# Technical Service Bulletin

## 19 Low coolant warning on; stone damage to intercooler radiator

19 15 59 2034439/3 April 10, 2015. Supersedes Technical Service Bulletin Group 19 number 13-45 dated September 3, 2013 for reasons listed below.

*Figure 2. Radiator protective grill.*

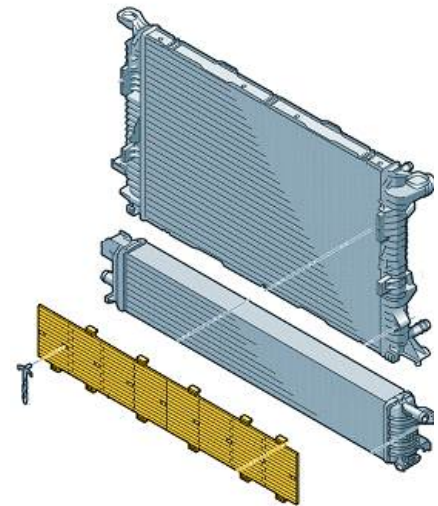
Beginning with CW15 2013, a protective grill has been added.

1. Verify that the coolant is leaking from the front intercooler radiator, and that the cause is stone damage.
2. Replace intercooler radiator and install a radiator protective grill (Figure 2) to prevent leaking. Follow instructions in Elsa.
